Network Rail The Quadrant:MK Elder Gate Milton Keynes MK1 9EN

No: NRS 320

# **Network Rail Safety Bulletin**

## **Trojan Trotred**

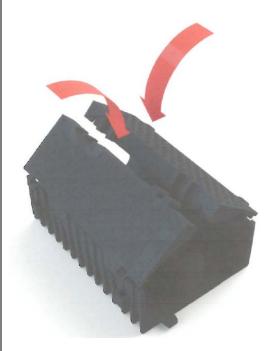
There have been two incidents of falling, by railway personnel, whilst walking on Trotred. The product has been approved for slip resistance, but there have been incidents where, following removal of the lids to install cables, the side walls of the Trotred have been deflected inwards due to weight from adjacent ballast and preventing the lids from being replaced correctly. This causes the outer edges of the Trotred lids to be unsupported and move unexpectedly under the weight of footfall thus creating a trip hazard.

Please ensure all TroTred lids are securely attached to the side walls and are not displaced from their correct positions.

Trojan are working to create a solution to the displacement of the TroTred lid. This involves;

- 1) redesigned lid to include lugs for the centre and increased antislip.
- 2) Further investigation and modelling by Trojan into the joint at the bottom of the trough to provide greater stability and resistance to side wall forces.

In addition the following technique should be employed when placing the lids in position. The outer edges of the lids should be positioned on the outer walls and the inner lid edges brought together, as in the picture below.
